Re: Change to Development Permit for Material Change of Use (AP2022/017) – Warehouse (Bulk Storage) and Transport Depot on land described as Lots 15 to 17 on SP338023 and Lot 26 on SP338024 and located at 39, 77, 91 and 95 Penelope Road, Stuart

The abovementioned Development Approval was issued by the Office of the Coordinator General on 19 April 2023 (refer **Attachment** 1). The purpose of the correspondence is to outline proposed changes to how stormwater quality is managed for the approved development and request the removal of the requirement to plant street trees.

#### **Revised Stormwater Quality Management Plan**

Figure 1 Proposed catchment of subject site (extract from Premise's SQMP)

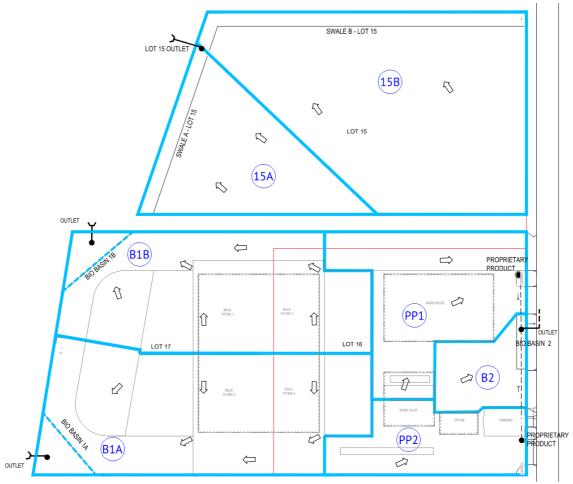
The approved Stormwater Quality Management Plan (SQMP) prepared by Premise outlined that the approved development has been designed to incorporate a combination of BioBasins, Swales, SPEL Stormsacks, and SPEL Hydrosystems (or approved equivalents) to provide stormwater quality treatment which achieves the State Planning Policy (SPP) Stormwater Management Design Objectives. The subject site catchments are illustrated in **Figure 1**.

The catchments for Lot 15 (catchments 15A and 15B) grade toward the north and west into swales, which leave the site via an outlet in the northwest and drain to an existing watercourse. The swales are pervious, whilst the remainder of the lot will be impervious. Therefore, the fraction impervious for these catchments has been calculated from these areas.

The catchments for Lot 16 and Lot 17 involve:

- Catchment B-1A takes half of the bulk storage centre roof run-off, half the silo storage centre, and half of the runoff from the roadway and manoeuvring areas. The catchment outlets into a Bioretention Basin 1A in the south-western corner of the site and is outletted into an existing drain;

- Catchment B-1B takes half of the bulk storage centre roof run-off, half the silo storage centre, and half of the roadway and manoeuvring areas runoff. The catchment outlets into a Bioretention Basin 1A in the north-western corner of the site and is outletted into an existing drain;

Figure 2 - Proposed Amended Stormwater Layout

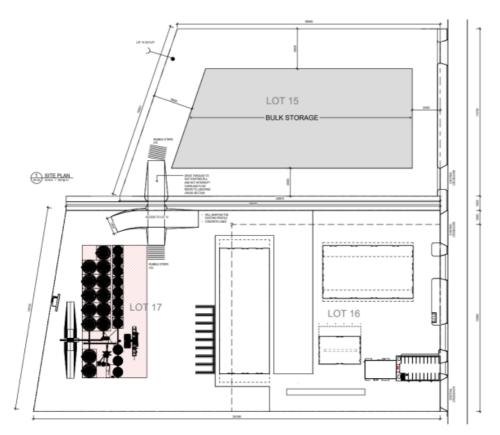
Langtree Consulting completed a review of the stormwater management regime for the whole of the western precinct of Cleveland Bay Industrial Park and have also reviewed the recommendations and conclusions of the Premise SQMP for Lots 15, 16 and 17, subsequent to the CG issuing Development Approval AP2022/017. As a result of the findings of the abovementioned reviews completed by Langtree Consulting, a new SQMP has been prepared for Lots 15, 16 and 17 (refer **Appendix 3**). The review concluded that the bio basins within Lot 17 are not required and therefore have been deleted, refer to Figure 2 below.

Figure 3 - Existing Stormwater Treatment Catchments

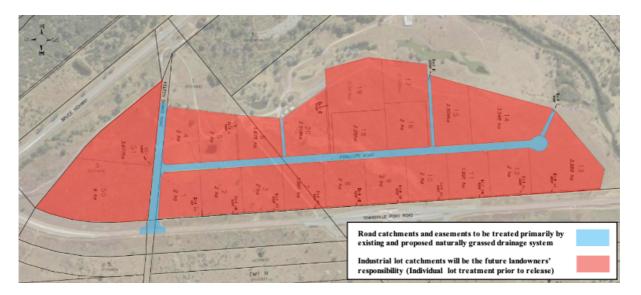
The revised SQMP, outlines that the stormwater catchments will be treated by individual lot treatment systems, which will be constructed by landowners prior to discharging to existing and constructed naturally grassed open drains within the balance area (Lot 24). This area is shown in **Figure 3** in red. Roadway/easement areas that will be treated via the existing and constructed naturally grassed open drains is shown in blue. It is noted that stormwater from Lots 16 and 18 fall towards Penelope Road and have been assumed to be treated by individual lot system by the lot owners before entering individual field inlet pits which discharging into the positive stormwater network prior to release to the naturally grassed open drains in the balance area.

Figure 6. Revised modelled drainage plan

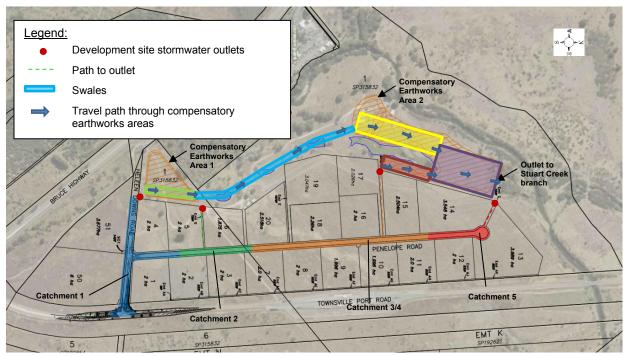
Please note the as built form of the CBIP development has been constructed with significantly wider swales and larger compensatory earthworks areas then was originally modelled. The constructed built form of the CBIP development is shown in Figure 6.

As a direct result, a review of the previous stormwater quality modelling with respect to the as built form of the CBIP has found that the existing model is very conservative and does not represent as built form of the CBIP development.

Figure 8. Revised Stormwater Treatment Catchments

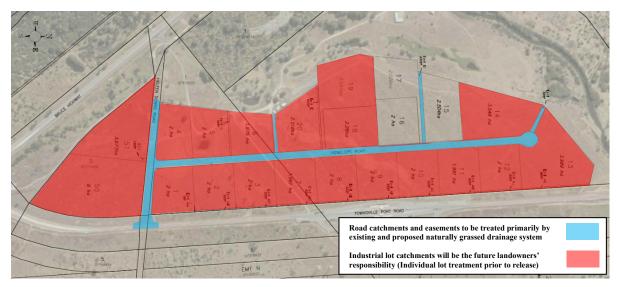
Therefore the proposed stormwater treatment area of the CBIP Western Precinct is shown in Figure 8

Figure 9. Modified MUSIC Modelling Diagram

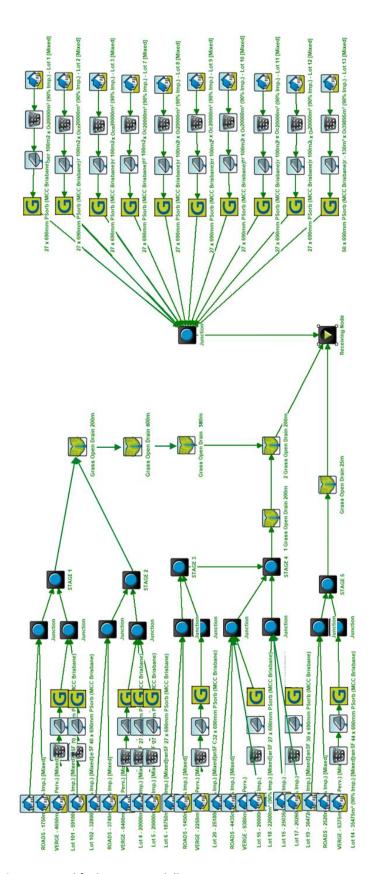
The updated MUSIC Modelling Diagram is Shown in Figure 9.
